Access Compliance Report

Public Rights-of-Way

(Curb Ramps)

Intersection ID: 10101	Main Street: JENKINS_ST	Cross Street: MILL_RD	Location: NE
ADA ID: FF148BB5FD8B	Ramp Type: PerpDiag	Initial Pass/Fail: Fail	Overall Compliance: No
Severity Score: 8.75			
Codes/Mitigation Info/Possible Solution		Field Measurements/Component Compliance

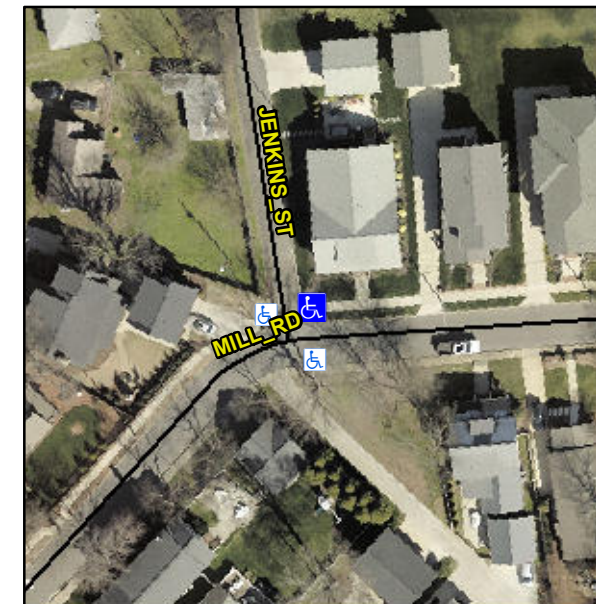
Remove & Replace Curb Ramp With Two New Directional Ramps or Equivalent.

R304.5.1
